Design Review Board Case # 20-0003
Blocks 4&5 – Carlyle Crossing Coordinated Sign Plan

Application	General Data	
Project Name: Carlyle Crossing Coordinated Sign Plan Special Use Permit Location: Blocks 4 & 5 – Eisenhower East 2410 and 2460 Mill Road Applicant: HTC 4/5 Project Owner LLC	DRB Date:	December 17, 2020
	Site Area:	5.07 acres
	Zone:	CDD #2
	Proposed Use:	Residential, Retail, Parking
	Gross Floor Area:	1,021,711 sf
Purpose of Application: DRB review and approval of a Coordinated Sign Plan for the Carlyle Crossing mixed-use project. The plan proposes a program of design guidelines, principles, and regulations for signage to include street- and upper-level retail signage, residential identity signage, and other site signage.		
Staff Reviewers: Robert M. Kerns, AICP robert.kerns@alexandriava.gov Thomas H. Canfield, AIA tom.canfield@alexandriava.gov Nathan Imm nathan.imm@alexandriava.gov Carson Lucarelli carson.lucarelli@alexandriava.gov Bill Cook william.cook@alexandriava.gov

i. Ground Level Signage

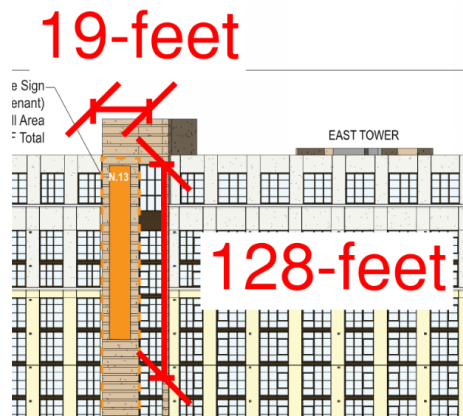
The Applicant proposes 1,577 square feet of retail, residential and parking garage related signage along the first-floor level, below 35-feet in height. The Applicant is requesting a ratio of 1.5 square feet per to 1 linear square feet of frontage, instead of the ordinance required 1:1. Given the size and scale of the development, Staff find that the signage proposed at these location to be generally acceptable. Blade signage is proposed at the pedestrian scale and is also found to appropriately located and sized.

iii. Skyline Signage.

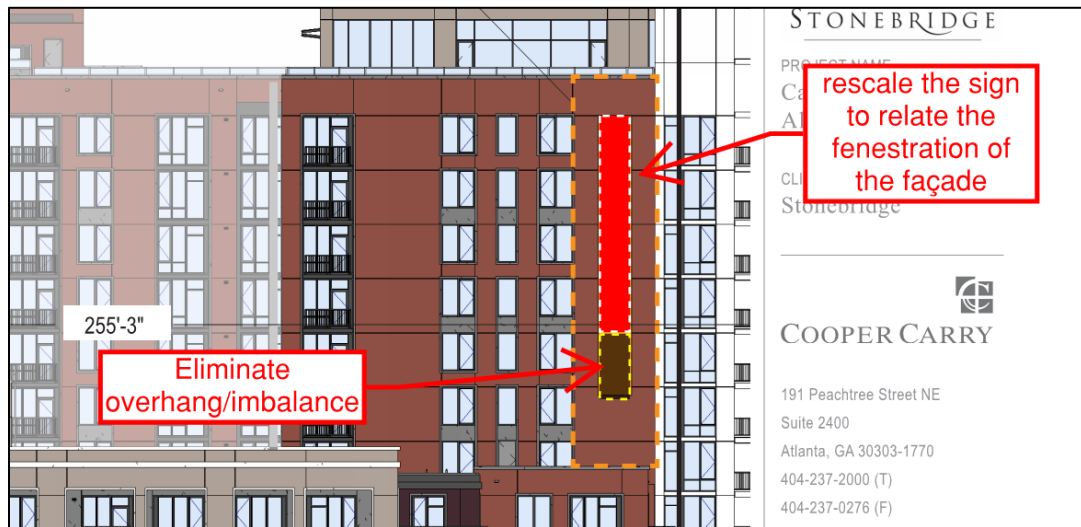
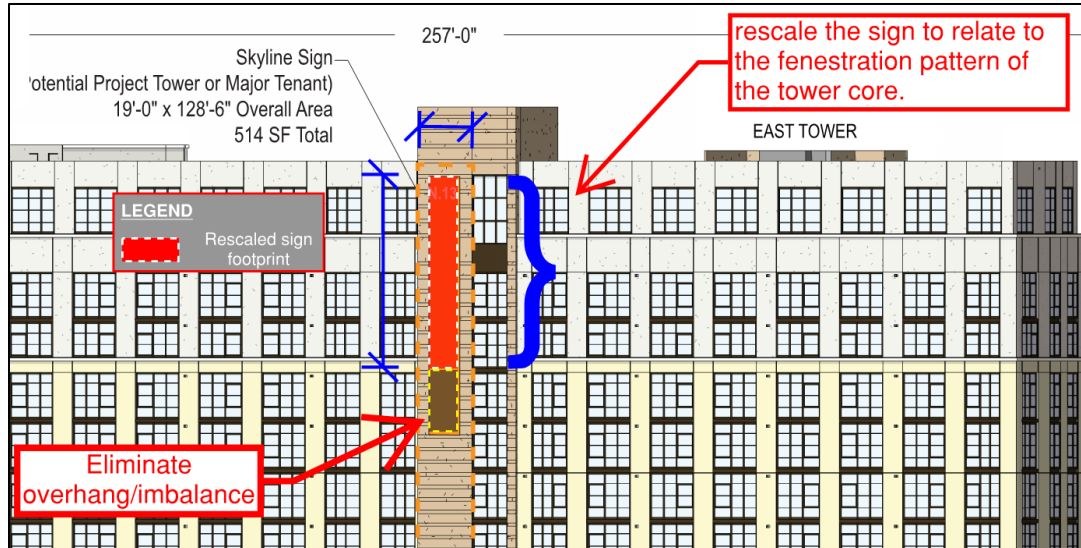
The Applicant is requesting approval of two skyline signs totaling 1,025 square feet at a requested ratio of 2:1. They are proposed along the southern and northern elevations and reserved for either the project name or major tenant. The size and scale, roughly twice the sign of a tractor trailer, are difficult to support and staff has encouraged the applicant to consider a scale which is more responsive to the architectural elements of the building. Given the requested scaling of the signage and lettering, Staff find that the skyline signs will appear more like advertisements,

rather than a marquee for the building. Additionally, there is concern that at the requested height of approximately 200-feet, the north facing skyline sign would be visible from the Masonic Temple.
